## Fwd: FW: Revised Calvert Road Bridge

Re: Bridge Savings Proposal-Calvert City Rd over Howards Branch

BRIDGE REPLACEMENT  
CALVERT CITY ROAD  
CALVERT CITY, KY

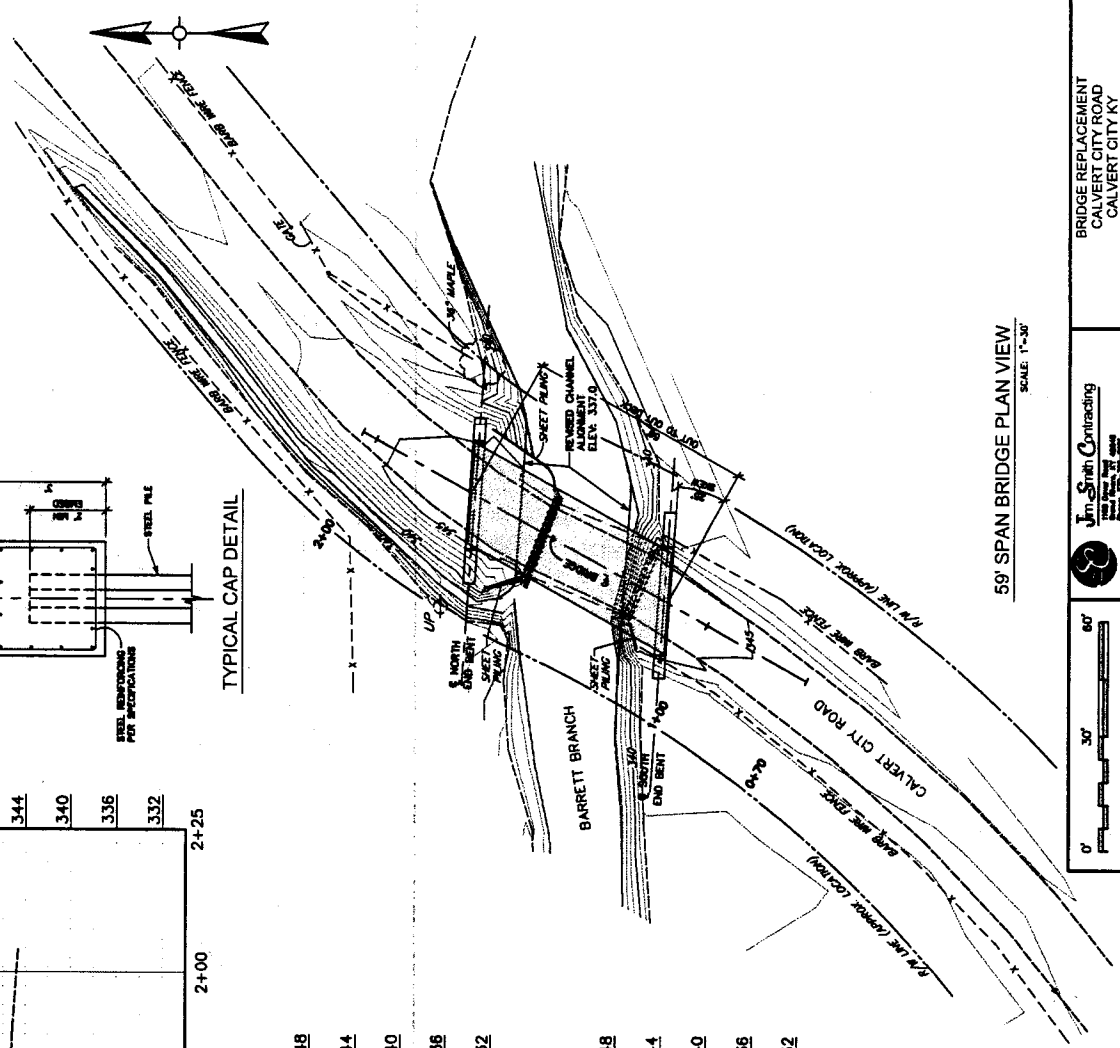
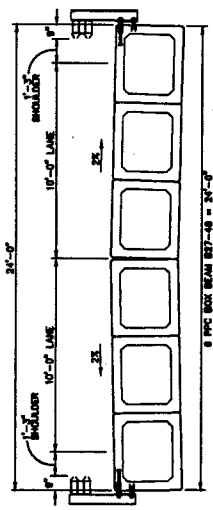
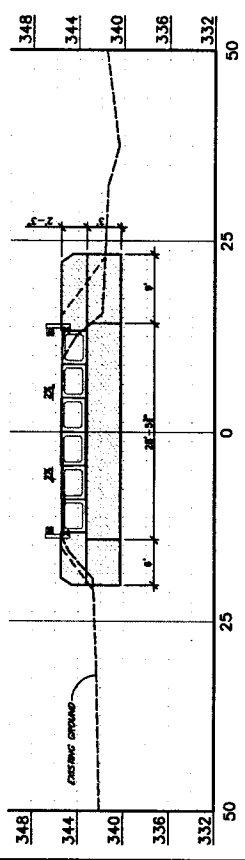
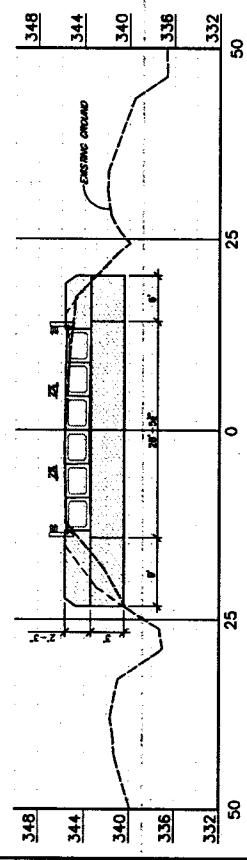
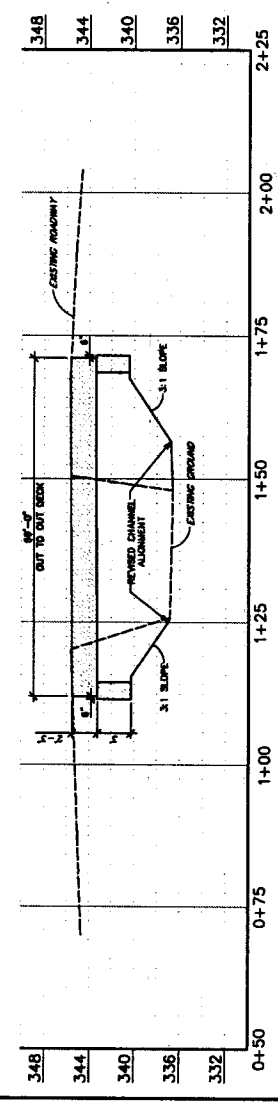
Here's the two prints our surveyors worked up I mentioned earlier. One is the project as bid at 74'. The other is shorting the bridge to 59' which leaves us with 3:1 slopes for rip rap in front of the abutments. I'd like to run through all the numbers one more time to verify accuracy then we will send over a savings proposal. If we don't find any busts in the calculations the savings will be around the \$20k mark which is simply the overall reduction in beam lengths. Only thing we will need then is a decision on which length so we can get beams ordered asap.

Jim Smith Contracting has conducted a detailed topographical survey of the Howard Branch Bridge on Calvert City Road. Our Engineering staff evaluated the existing creek and structure location then developed the attached site plan for realigning the creek channel and installing the 74' bridge length as specified in the bid documents. Upon closer review, it has been determined that a 59' bridge length was achievable and still allow sufficient room for a 3:1 slope between the bridge abutments and the creek channel. Jim Smith Contracting therefore can offer a total cost savings of **\$21,924.00** by reducing the bridge length to 59' as shown in the attached revised drawing. Please review and advise if the County wishes to pursue this savings option.
